Access Compliance Report

Public Rights-of-Way

Intersection ID: 47838	Main Street: SPUR_RANCH_RD	Cross Street: ALVARADO_WY	Location: NE
ADA ID: 86A05DCA4703	Ramp Type: PerpDiag	Initial Pass/Fail: Fail	Overall Compliance: No
		Severity Score: 10

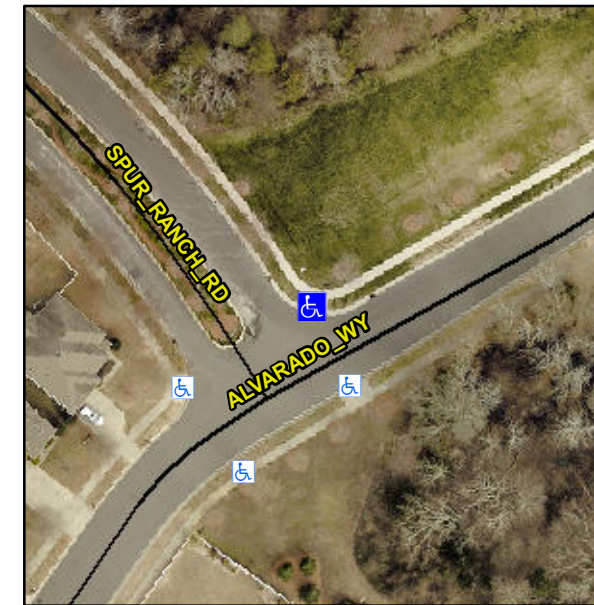
R304.5.1, R304.5.3

Compliance	Description	Data	Compliance	Description	Data
N/A	Ramp Length (in)	133.0	Yes	Ramp Slope (%)	5.7
No	Ramp Width (in)	44.0	No	Ramp XSlope (%)	3.9
N/A	Flare Type LT	N/A	N/A	Flare Type RT	N/A
N/A	Flare Slope LT (%)	N/A	N/A	Flare Slope RT (%)	N/A
N/A	Flare Traversable LT?	N/A	N/A	Flare Traversable RT?	N/A
N/A	Landing Length (in)	N/A	N/A	DWS Provided?	N/A
N/A	Landing Width (in)	N/A	N/A	DWS Contrast?	N/A
N/A	Landing Slope (%)	N/A	N/A	DWS Length (in)	N/A
N/A	Landing X Slope (%)	N/A	N/A	DWS Full Width?	N/A
N/A	Landing Curb? (Y/N)	N/A	N/A	DWS Offset (in)	N/A
N/A	Shared Landing?	N/A			
N/A	Gutter Ponding?	N/A	N/A	Gutter Slope (%)	N/A
N/A	Gutter Lip Ht (in)	N/A	N/A	Gutter X Slope (%)	N/A
N/A	Painted X Walk1?	No	N/A	Painted X Walk2?	No
	X Walk 1 Direction	To SW		X Walk 2 Direction	To SE
N/A	X Walk 1 Width (in)	N/A	N/A	X Walk 2 Width (in)	N/A
	X Walk 1 Slope (%)	0.9		X Walk 2 Slope (%)	1.6
	X Walk 1 X Slope (%)	1.5		X Walk 2 X Slope (%)	0.6

Remove & Replace Curb Ramp With Two New Directional Ramps or Equivalent.
